AGENDA
Special Meeting
VILLAGE OF PLEASANT PRAIRIE
PLEASANT PRAIRIE VILLAGE BOARD
Village Hall Auditorium
9915 – 39th Avenue
Pleasant Prairie, WI
January 30, 2012
Immediately following the 6 p.m.
Plan Commission Meeting

VILLAGE STAFF REPORT OF JANUARY 30, 2012

Consider the request of Jonah Hetland, agent for BFU II LLC, owner of the property located at the southeast corner of 91st Street and 22nd Avenue for approval of a **Conceptual Plan** for a 46-unit affordable, independent senior-only apartment complex.

CONCEPTUAL PLAN FOR PROPOSED SENIOR HOUSING PROJECT: At this time, the Developer is proposing to develop a two (2) story building with 46-units of affordable, independent senior apartments on the 3.2 acre property located at the southeast corner of 91st Street and 22nd Avenue.

| SHEET NO. C-3 | |

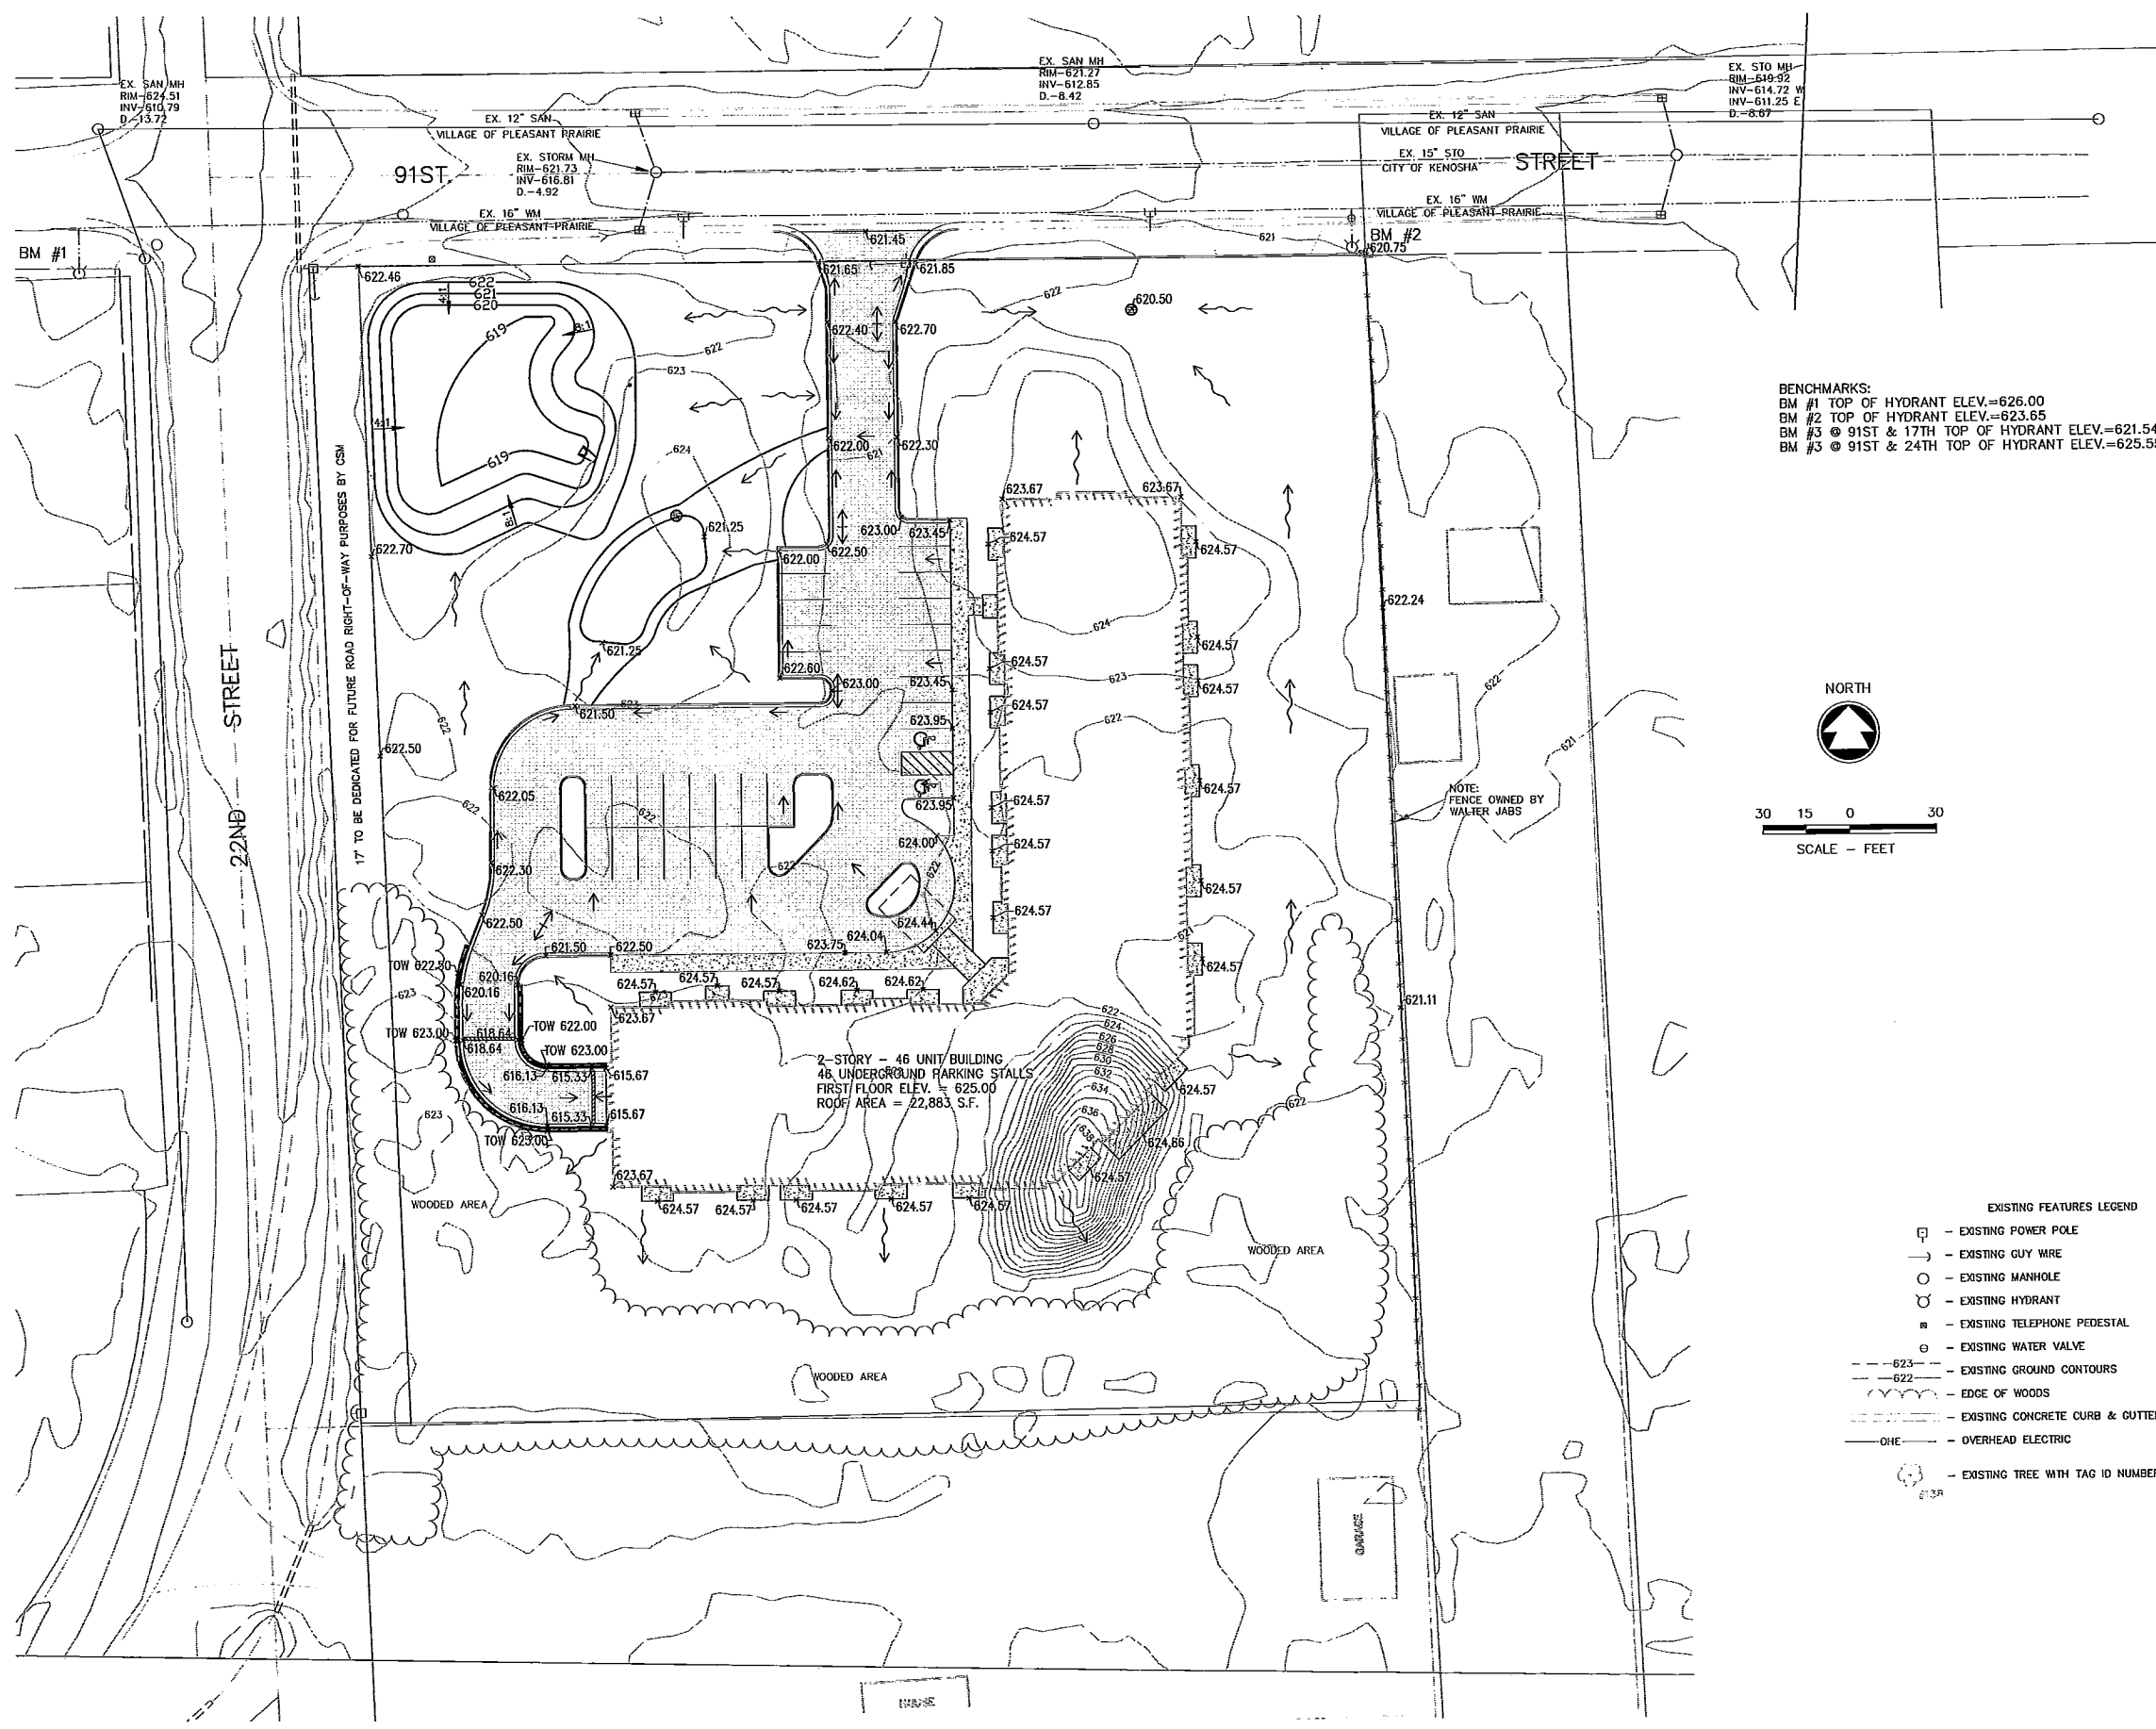
- iii. The proposed storm water management approach and system functionality is unclear in the conceptual plans.
- iv. Based on the elevations provided on the conceptual plan, the trench drain to the parking garage is lower than the storm sewer within 91st Street.

SITE PLAN
1" = 30'-0"
HOUSE

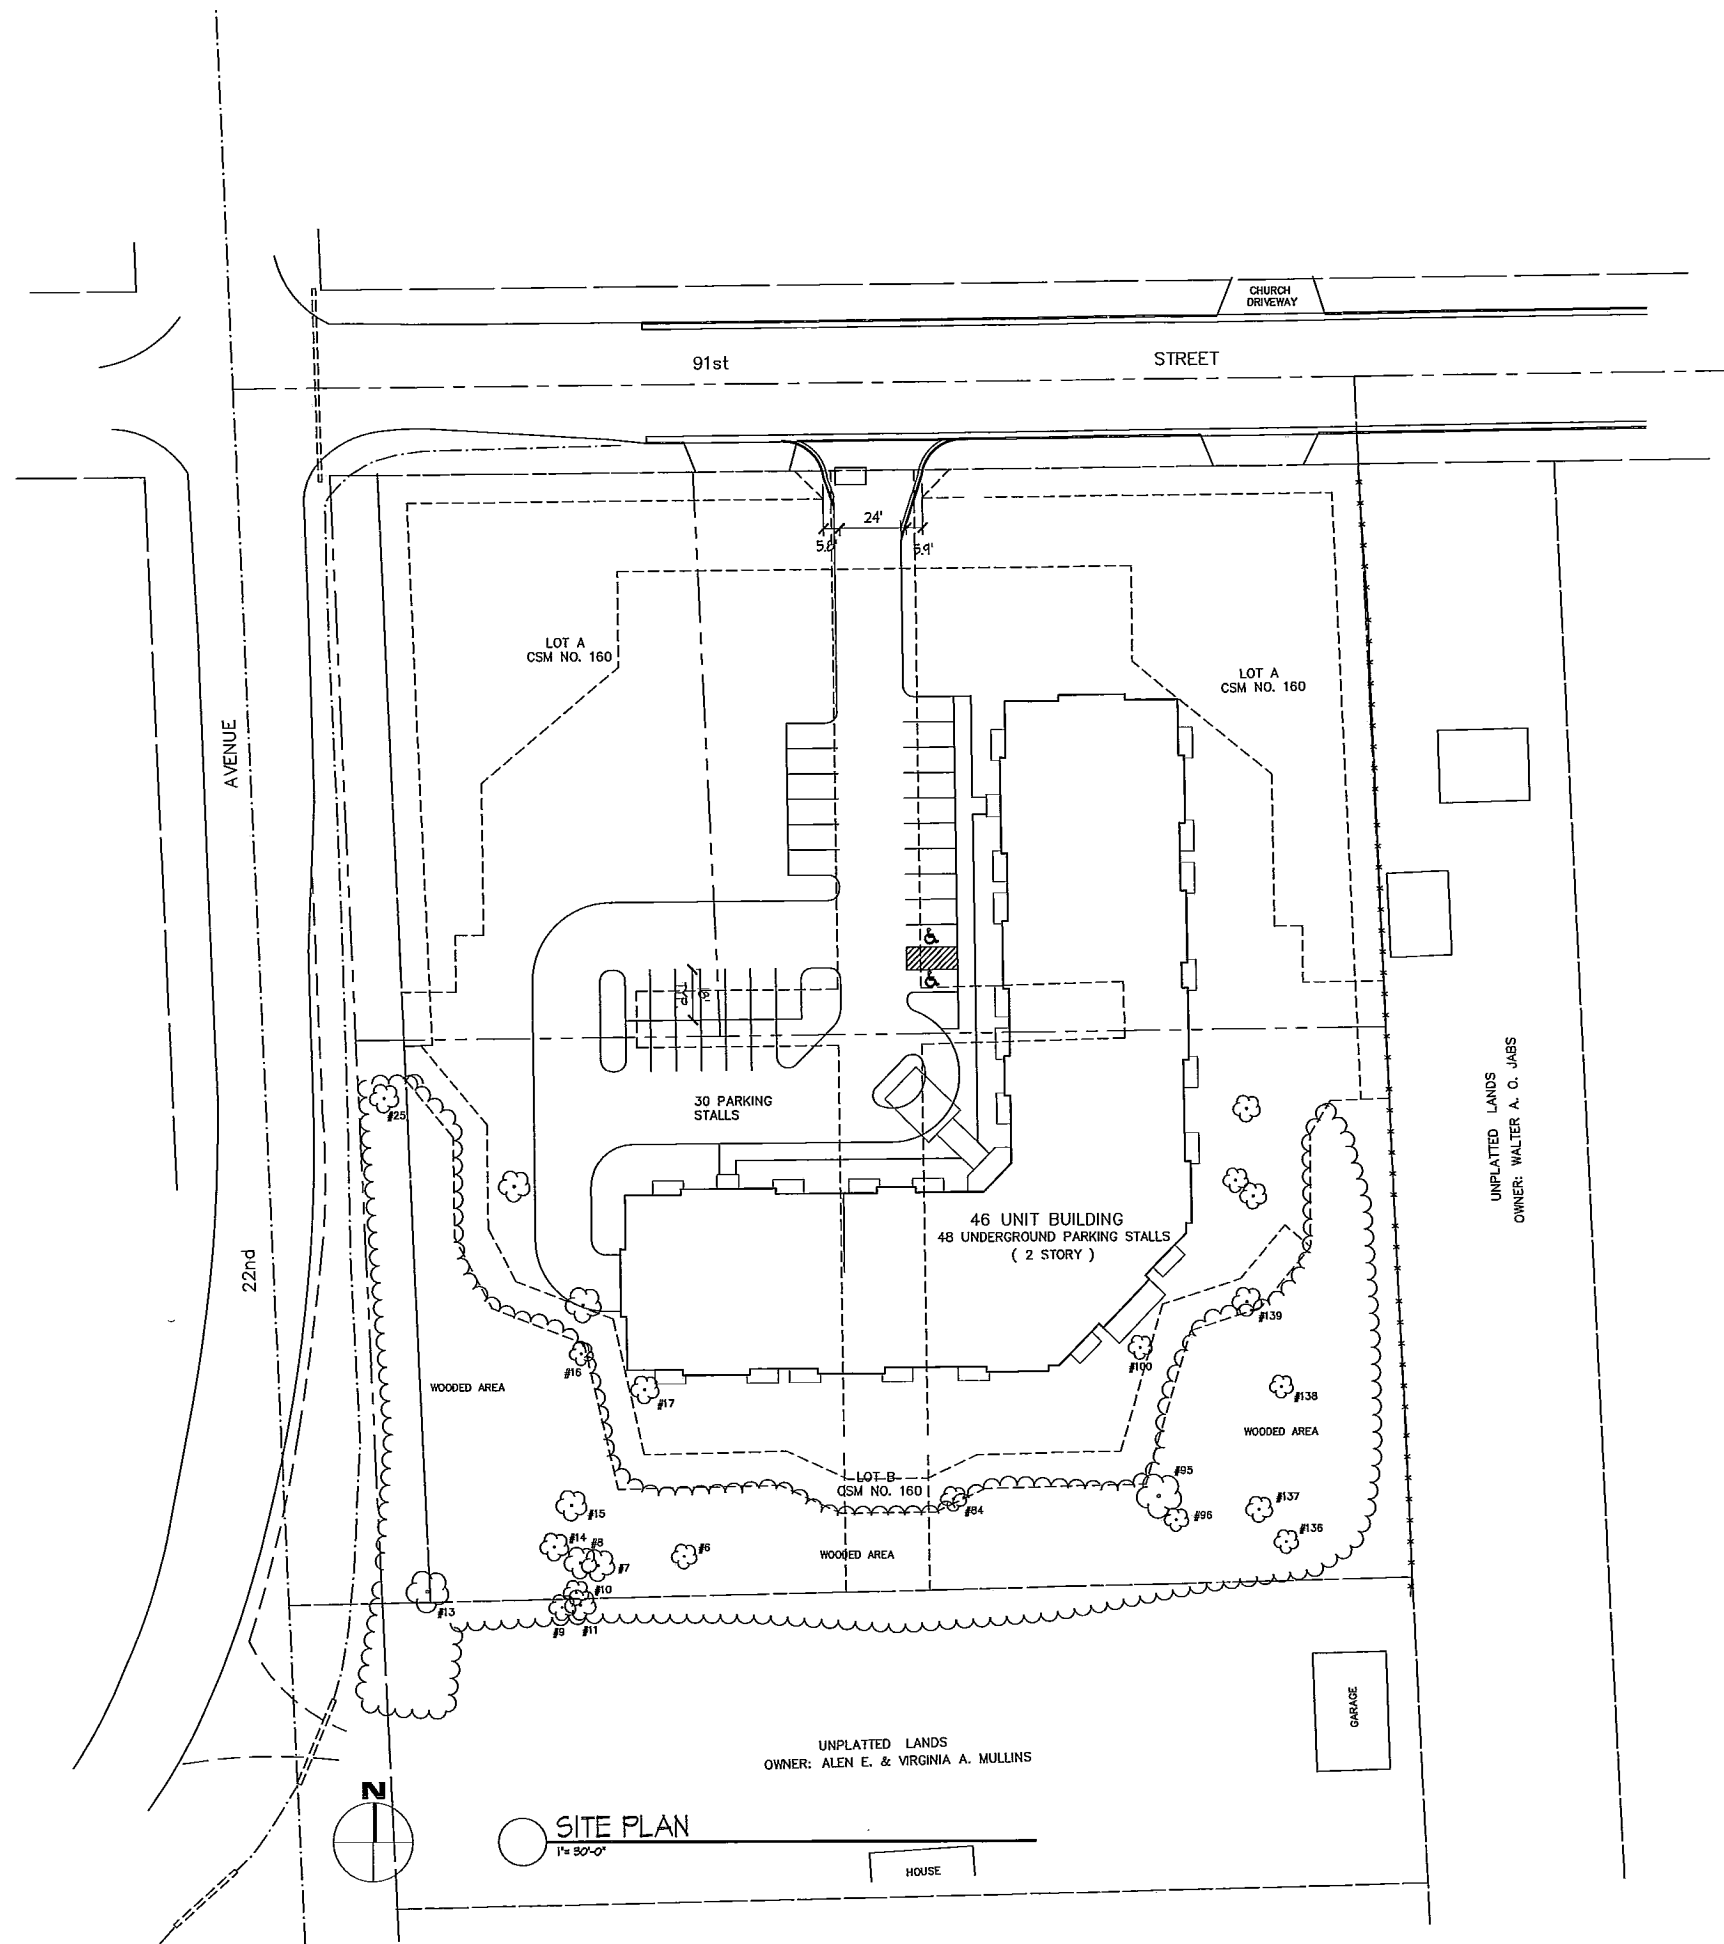
- a. The parking lot shall accommodate fire truck turning movements for ingress/egress. A turning template shall be provided showing truck turning movements. Provide plan sheet with the turning template.

- b. The driveway leading into the underground parking shall be a minimum of 24 feet wide.
- c. Label the City of Kenosha – Village of Pleasant Prairie municipal border along 91st Street on all plan sheets.

- s. The location of the proposed garbage and recycling collection area shall be shown on the plans. A standalone dumpster will not be allowed. The dumpster area shall be incorporated into the design of the building.

Project No. 1128 Drawing No. A-2.1

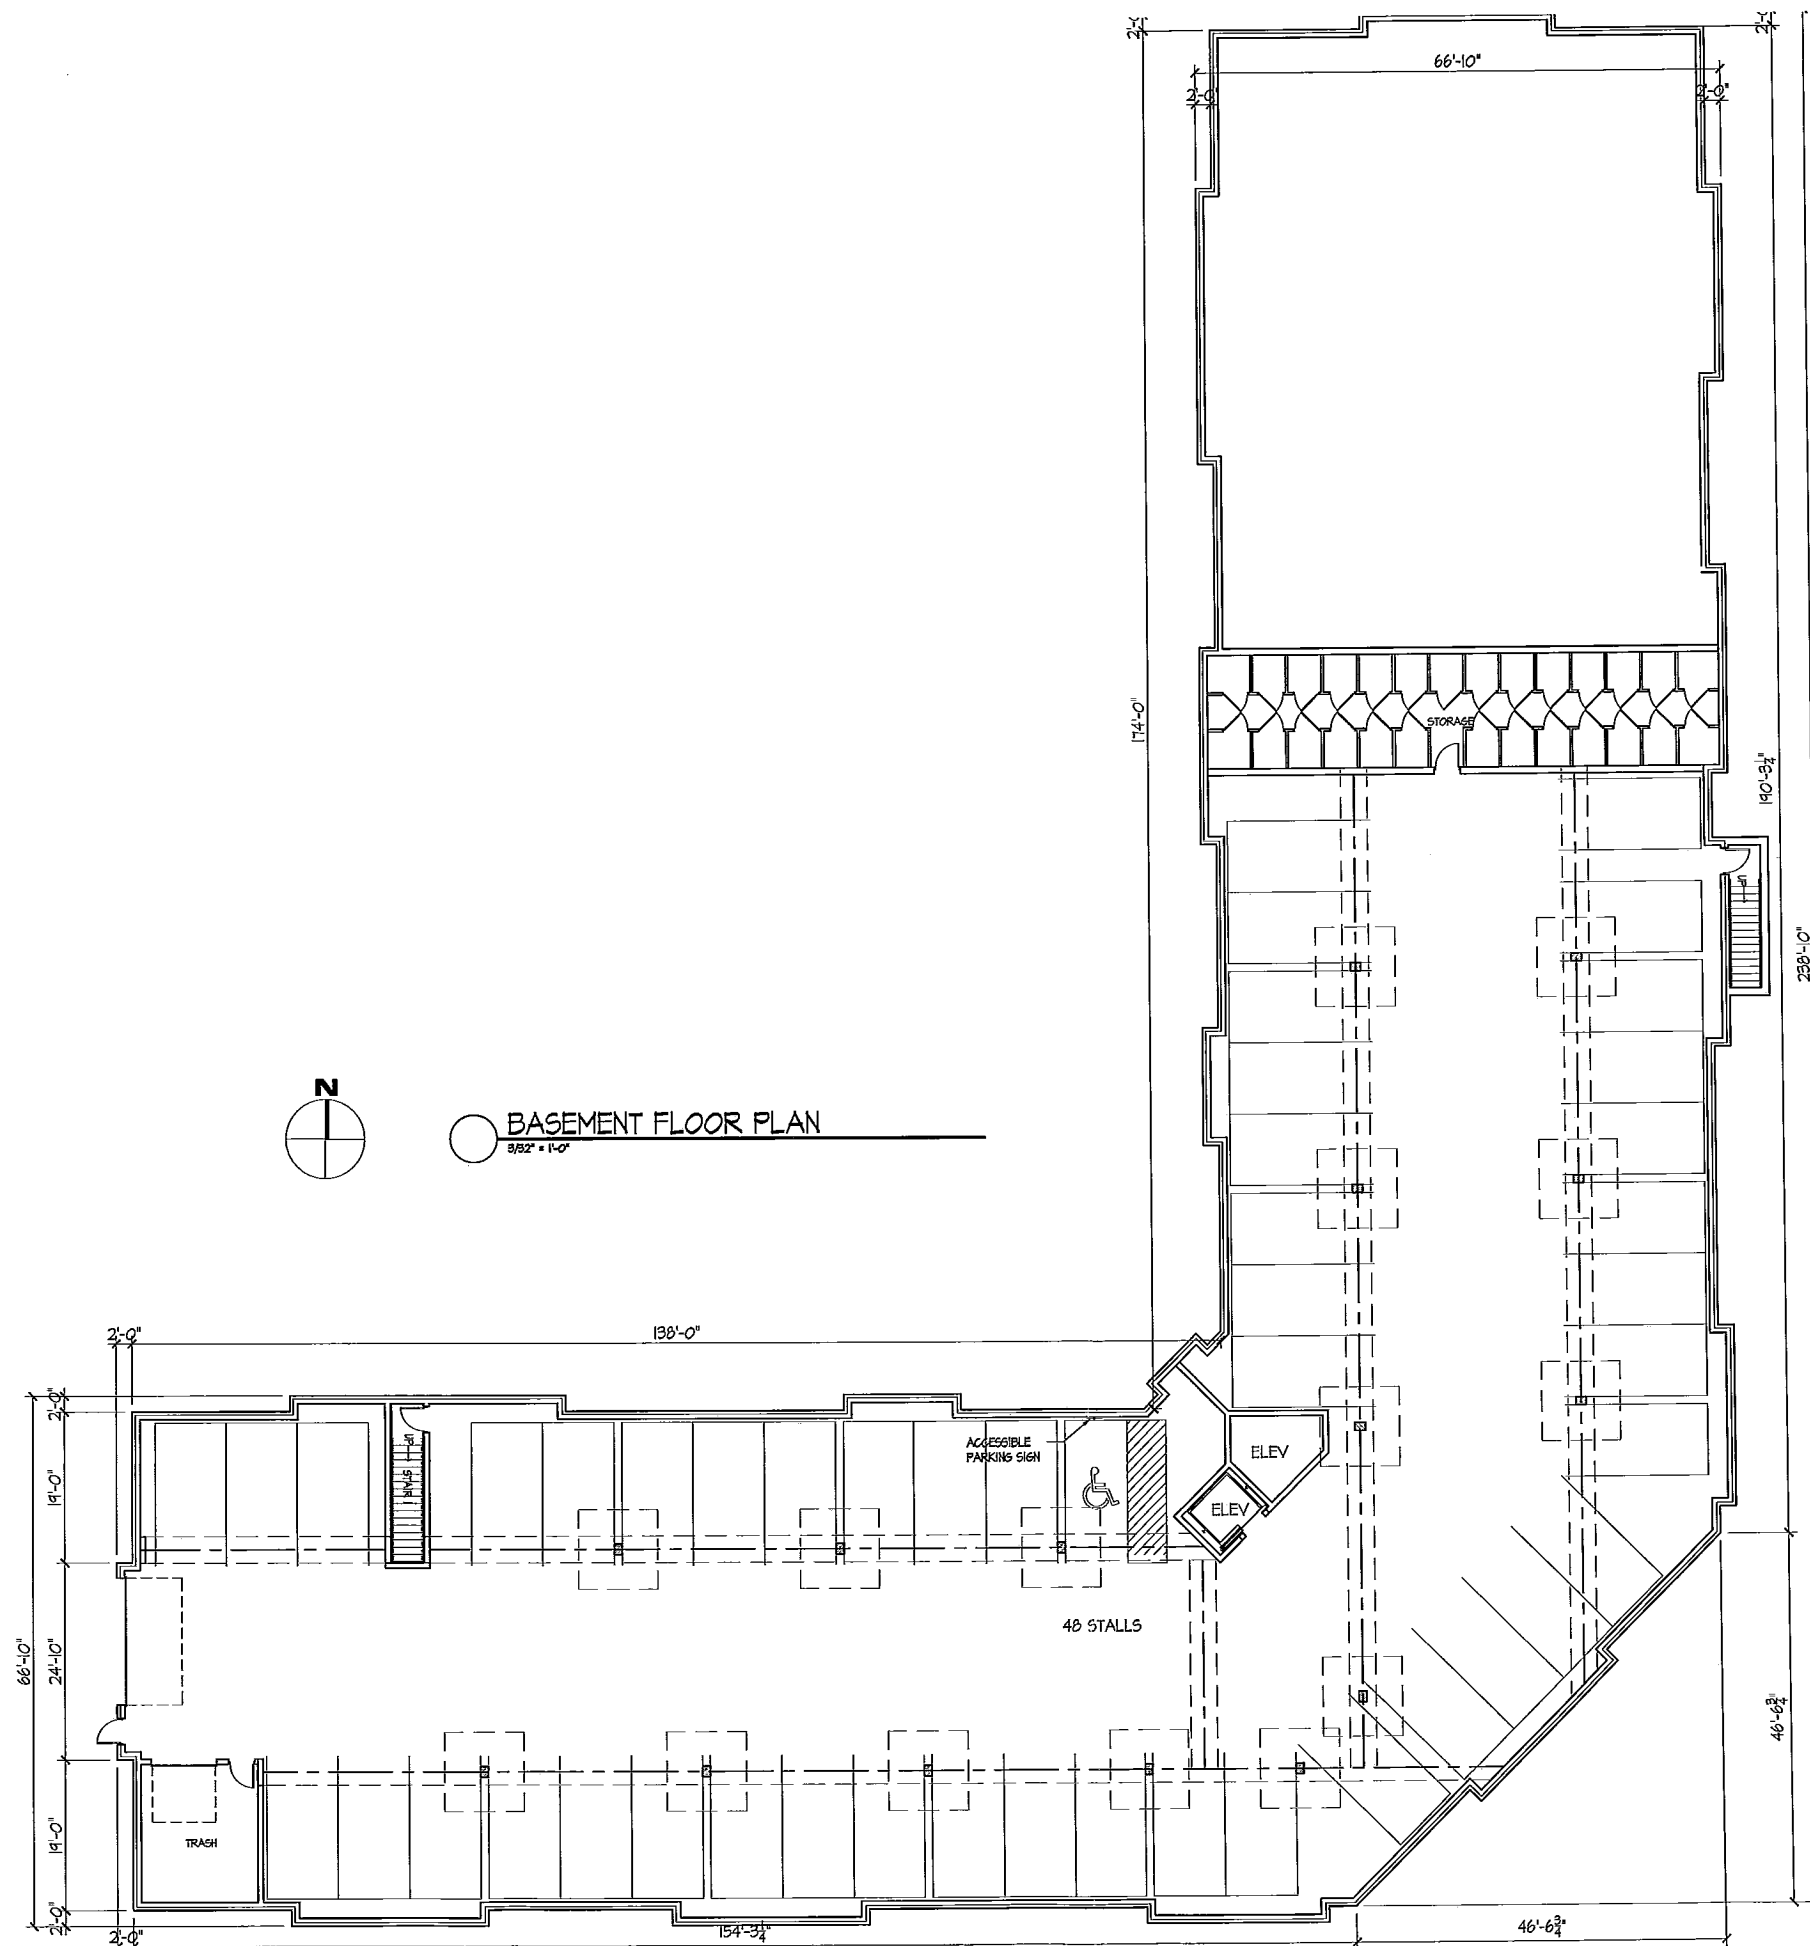
- t. The minimum roof pitch shall be 4:12. Note on the plans.

- u. A minimum of 50% of each wall surface, excluding windows, doors and garage doors, shall be constructed of brick, stone, masonry or concrete. Although Hardy-Plank is a concrete product, this is excluded in the 50% calculations. Color elevations of all sides of the building shall be submitted for review. Additional changes to the elevations may be required upon further staff review.

- v. Material sample boards shall be provided for Plan Commission review and approval.
- w. The total building height shall be shown on the plans. The building shall not exceed 35 feet in height.

Canopy Entrance:
Canopy clearances shall be at least 14'-0". All clearance heights shall be clearly identified. The width of the canopy must be able to accommodate emergency apparatus. **Plans dated 12/16/11 show the canopy at 8 feet in height. Minimum clearance needs to be 14'-0".**
